August 6, 2013

ISSUED FOR USE  
EBA FILE: W14103179-01

**Subject:** June 2013 Geotechnical Inspection of Earth Structures  
Mount Nansen Site, YT.

Photo 7: Seepage observed from base of sand terrace at north side of seepage collection pond (June 21/13).

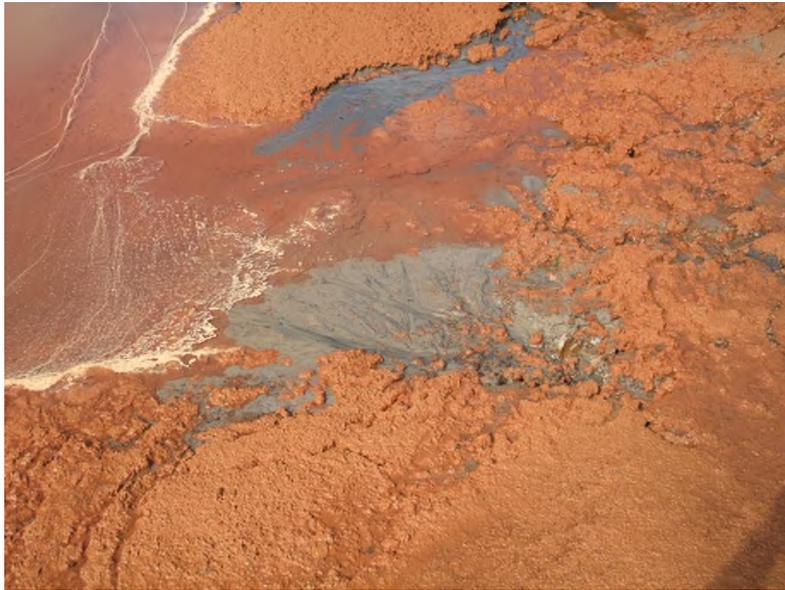
Photo 7 shows one of these seepage zones from the base of the sand terrace on the north side of the pond. The water was observed to be clear, and the small alluvial fan visible in the photo is the result of erosion of the natural sand surface by moving water, not by subsurface piping.
